Quality Control Check Report. Stage: After Finishing Stage III (Apartments)

Flat No	406	Other	—	Sl. No.	42954
Company	MRGV	Project	BRGV	Phase	
Prepared by	Abhishek Gautam	Sign	<i>Abhishek</i>	Date	23-05-24
Project Manager	SARWAR	Sign	<i>Sarwar</i>	Date	23-05-24
Previous stage report no.	42235	Report filed and signed by PM		☒ Yes ☐ No	
Checked By MD on		MD Sign		For filling	☐ Yes ☐ No

First Floor Typical Flat -
114, 116, 118, 120

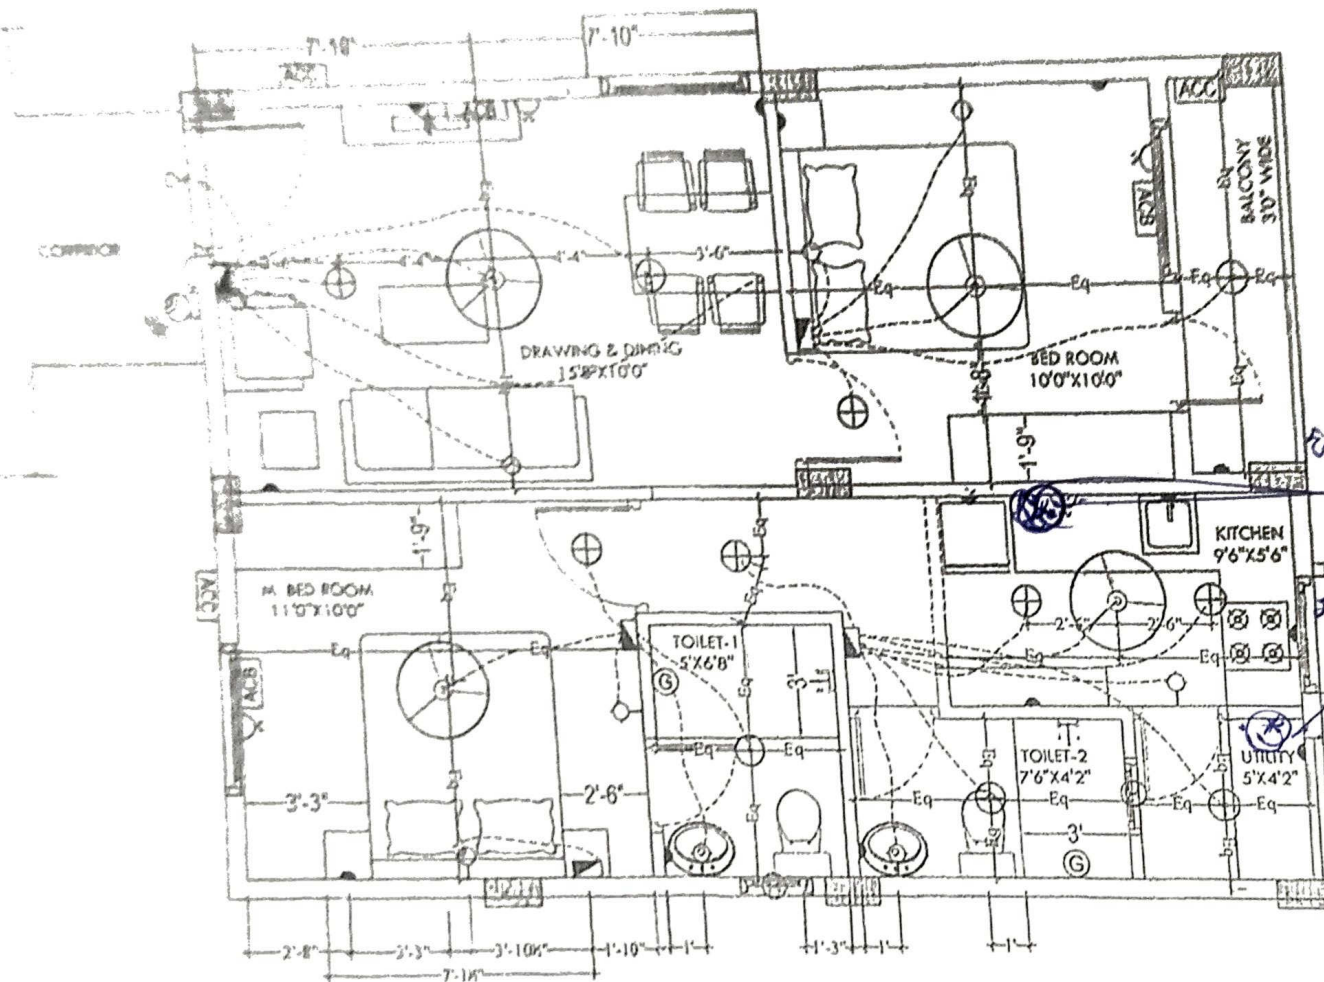
Changes in electrical points: (mark on plan)

(1) 16 Amp 1 x 16 point for kitchen. (1)

(2) 16 Amp 1 x 16 point for utility area. (1)
